Application for Kearl Mine's Tailings Management Plan

Alberta Energy Regulator

Decision 20180716A: Imperial Oil Resources Limited; Application for Kearl Mine's Tailings Management Plan

Figure 1. New fluid tailings profile

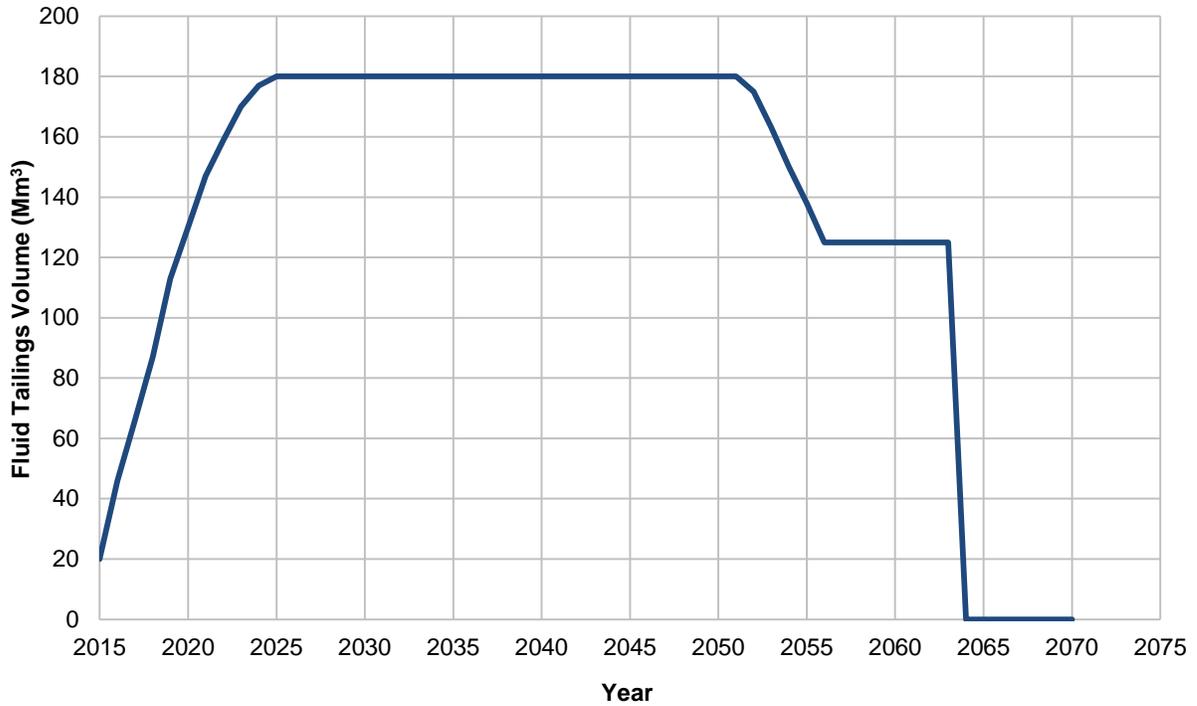
[29] Nevertheless, there are three issues with respect to Imperial’s new fluid tailings profile.

[30] First, given the stage of operations at Kearl, the profile is based on Imperial’s conservative assumptions regarding treatment technology performance and tailings deposit performance. Imperial acknowledged that it requires more time to verify its tailings treatment technology and deposit performance, and as a result Imperial used conservative assumptions to develop the new fluid tailings profile. The AER is concerned that as operations progress the new fluid tailings profile may not represent the actual performance of Kearl’s treatment technology and tailings deposit. Some SOC filers share this concern.

[34] The timing of the update aligns with Imperial's commitment to provide an updated new fluid tailings profile by 2020. The revised new fluid tailings profile must be supported by evidence to justify the technology and RTR criteria, as required by *Directive 085*.
